Our Ref: 23-1045
Your Ref: MCUC 2023_5563

RE: RESPONSE TO COUNCIL'S INFORMATION REQUEST ASSOCIATED WITH A MATERIAL CHANGE OF USE (DWELLING HOUSE) AT 12 MURPHY STREET PORT DOUGLAS.

**RFI CIVIL RESPONSE SUBMISSION
MCU - DWELLING HOUSES MCUC 2023_5563
12 MURPHY STREET, PORT DOUGLAS (L113 PTD2094)**

SITE PLAN

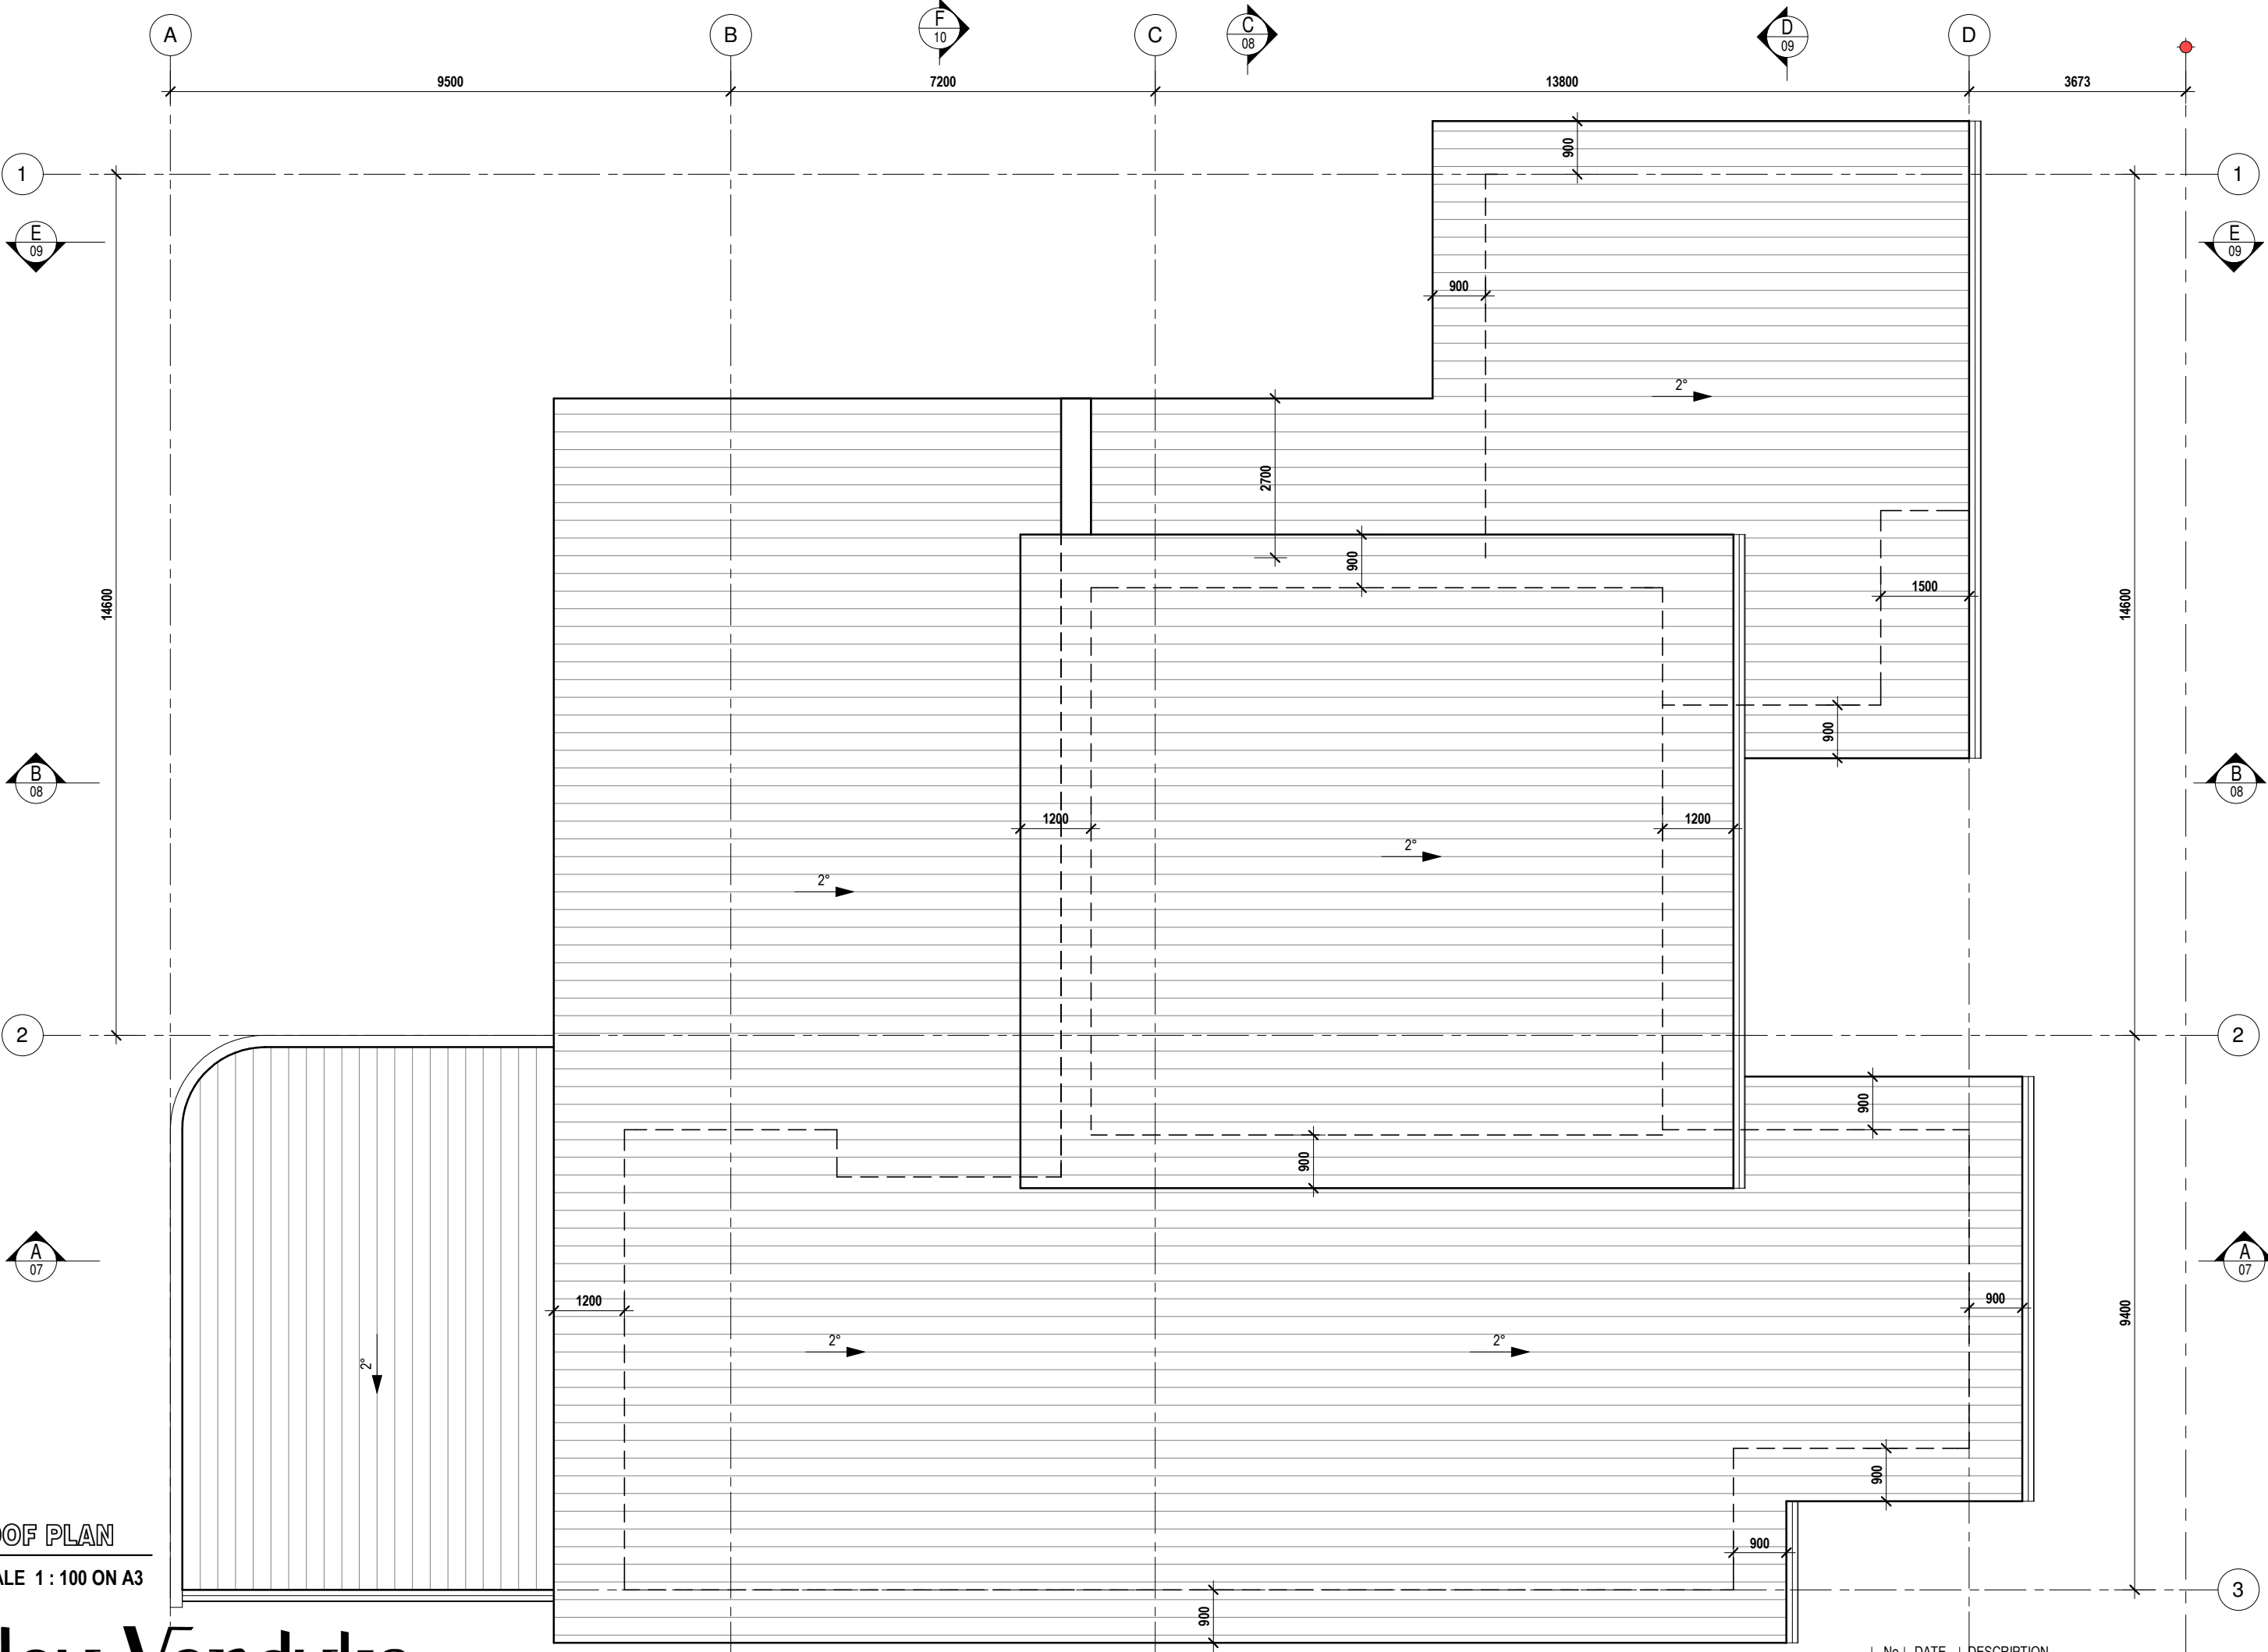
2. *Confirm the proposed width of the sealed access within the Murphy Street Road reserve. Officers note a 2.6m wide access is proposed on Balay Vandyke Drawing 7 of 14 (Site Plan - Revision F) for the frontage of the subject site. The application material does not demonstrate how access will be provided to Murphy Street sealed road formation. This lower section services 10, 12 and 14 Murphy Street. Concern is raised regarding the ability for vehicles using the shared access to safely pass one another at low speed without departing from the road. Reference is made to Complete Streets Table 6-2 for minimum widths for passing vehicles.*

3. *Clarify the proposed width of the sealed driveway internal to the development site. Officers note a 4m wide driveway is nominated on Balay Vandyke Drawing 7 of 14 (Site Plan - Revision F), however, the width shown on this drawing is scaled at approximately 2.6m.*

4. *Concern is raised regarding the requirement for a 1.8m retaining wall proposed in the Murphy Street Road reserve shown on Balay Vandyke Drawing 7 of 14 (Site Plan- Revision F). Note, the proposed retaining wall also appears to be located near the top of an existing steep batter which may have stability implications for the road reserve. Note that a retaining wall in road reserve of this height is considered to be an unacceptable solution.*

In particular, what treatment/s are proposed for the 3m high retaining walls shown on Balay Vandyke Drawing 7 of 14 (Site Plan - Revision F) along the western and northern extents of the dwelling house.

Council's assessment seeks additional technical information around allotment access, and this is resolved in the submitted Engineering Plans (Applin Consulting Engineers). In particular, the shared driveway is intended to have a nominal width of 4.5metre which is considered suitable for this low-speed environment and the internal access driveway width is intended to be 3.5 metres for private vehicle access.

The proposed shared driveway width is now 4.5m to reduce the footprint and ensure minimal impact to the existing trees by following the existing track alignment.

The internal driveway width for 12 Murphy Street is 3.5m.

The proposed driveway has been regraded slightly to negate the need for any retaining within the road reserve. Sketch plans of the driveway with a long section and cross sections are included in **Appendices A and B**.
